Polski Rejestr Statków

AMENDMENTS NO. 2/2012

PUBLICATION NO. 84/P

**REQUIREMENTS CONCERNING THE CONSTRUCTION
AND STRENGTH OF THE HULL AND HULL EQUIPMENT
OF SEA-GOING BULK CARRIERS OF 90 M IN LENGTH AND ABOVE**

Figure 1.4.3.4-2 Vertical extent of bilge plating within the cylindrical part of the hull

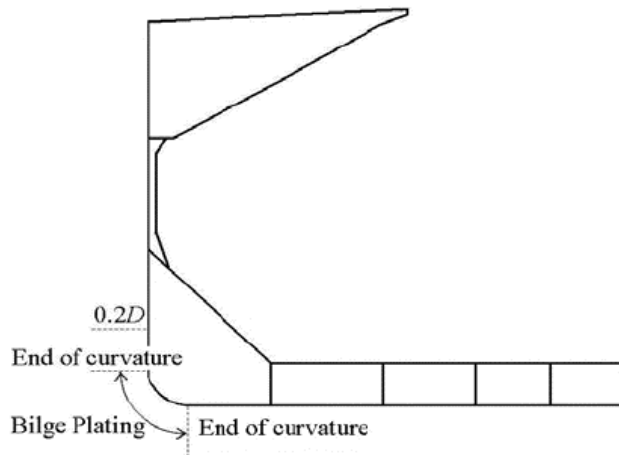
Bilge plating – The bilge plating is the curved plating between the bottom shell and side shell. It is to be taken as follows:
– within the cylindrical part of the ship (see Fig.1.4.3.4-2): from the start of the curvature at the lower turn of bilge on the bottom to the end of the curvature at the upper turn of the bilge;
– outside the cylindrical part of the ship (see Fig.1.4.3.4-3): from the start of the curvature at the lower turn of the bilge on the bottom to the lesser of:
  a)   a point on the side shell located $0.2D$ above the baseline/local center-line elevation,

b)   the end of the curvature at the upper turn of the bilge.
